**Racine Water and  
Wastewater Utilities**

SUBJECT: Change Order No. 1 – Contract W-19-10 – Spring Street Transmission Water Main –  
Phase 3

Date of Issuance: November 12, 2020	Effective Owner:	Upon Signature of Owner Racine Water & Waste Water Utility
Contract: Spring Street Transmission Water Main Phase 3	Owner's Contract No.:	W-19-10
Contractor: S.J. Louis Construction	Engineer:	Ruekert & Mielke, Inc.
Address: 1351 Broadway Street W. Rockville, MN 56369	Engineer's Project No.:	8022-10029.313
	Effective Date of Contract:	August 19, 2019

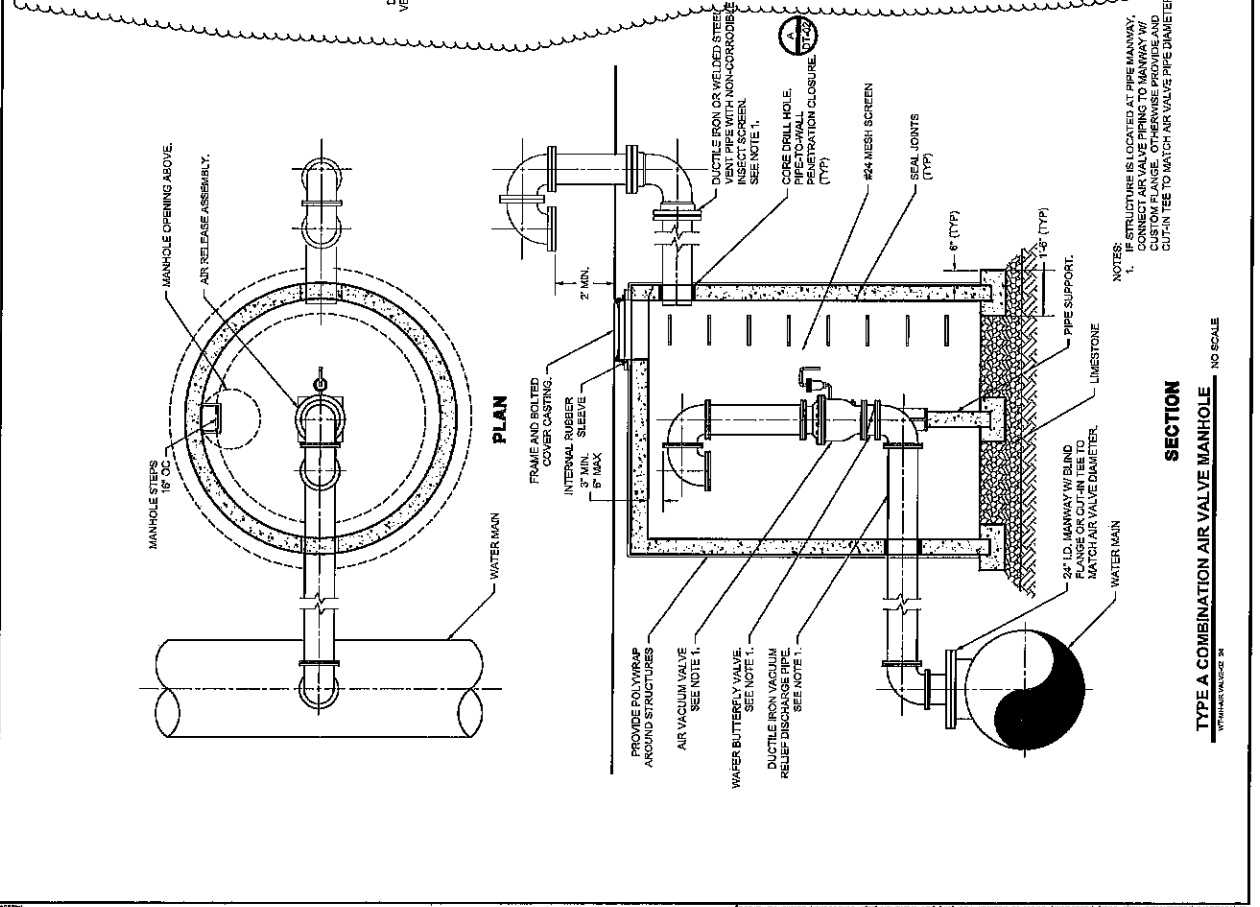
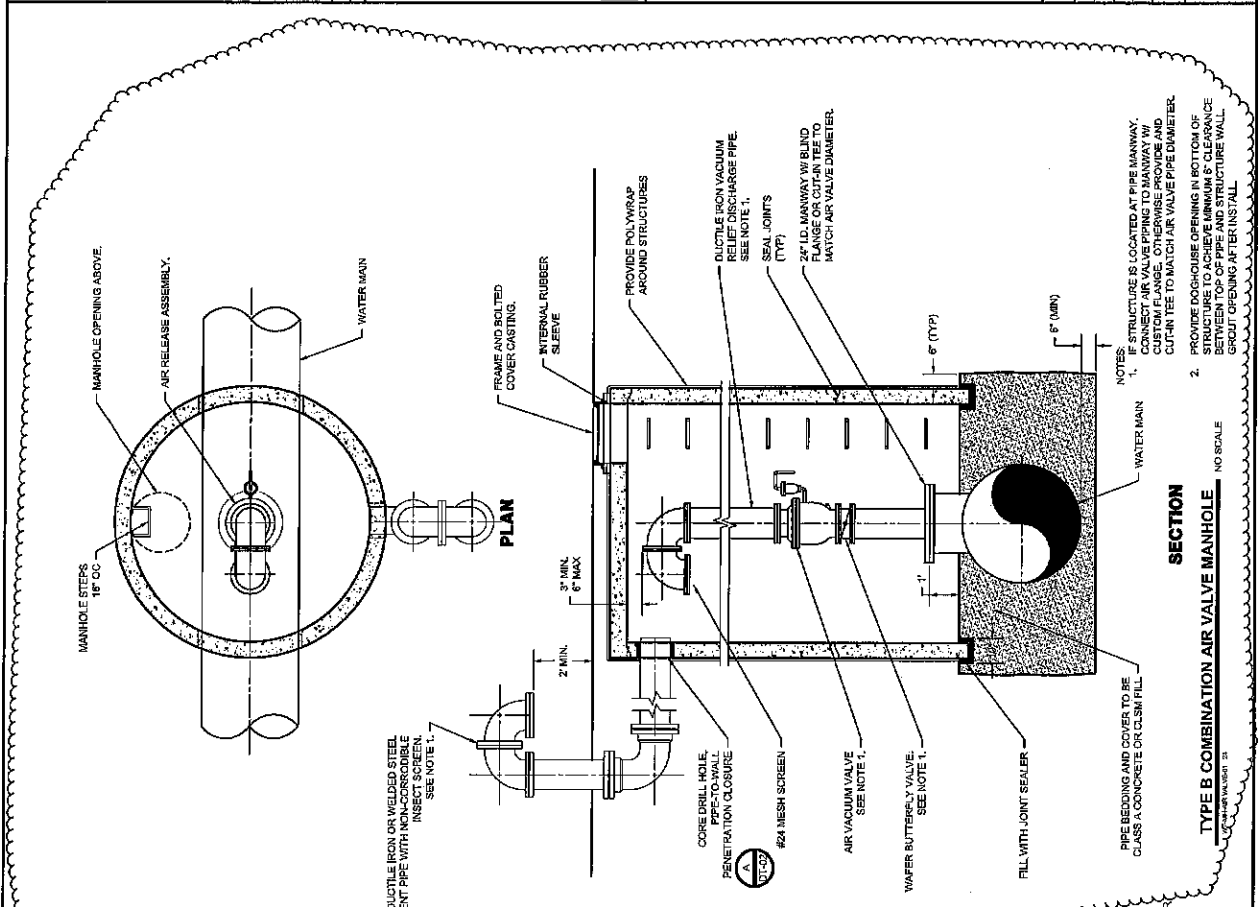
Please consider this letter as a Change Order Request for an adjustment of Contract Price & Time in accordance with Article 11 of the Standard General Conditions. SJ Louis is requesting \$288,000.00 for the labor, equipment & material to install five (5) Air Vacuum Assemblies per the details supplied by Ruekert & Mielke. SJ Louis anticipates twelve (12) working days to complete the installation of the Air Vacuum Assemblies. However, SJ Louis requests an equitable extension of Contract Time for procurement and delivery of materials incorporated in this change. SJ Louis' supplier has stated the Air Valves are approximately 10-32 weeks from approved submittal.

Enclosures: Airvac Schedule – RM Supplied  
Airvac Detail – RM Supplied  
CC: Bob Schueller, SJ Louis

1. Manhole frame/casting for each structure to be Neenah R-1739 ALM.
2. Air vacuum valves to be either Val-Matic 150 SF Series with attached air release valve (combination type), or APCO Series 1800/1100A (combination type). Each valve to contain discharge pipe with gooseneck instead of protector hood. Air release valve orifice size to be 0.75 inches for all assemblies.
3. Single-valve type structures and dual-valve type structures may be substituted for each other at Contractor's request upon Engineer's approval.
4. Install according to manufacturer's recommendations.
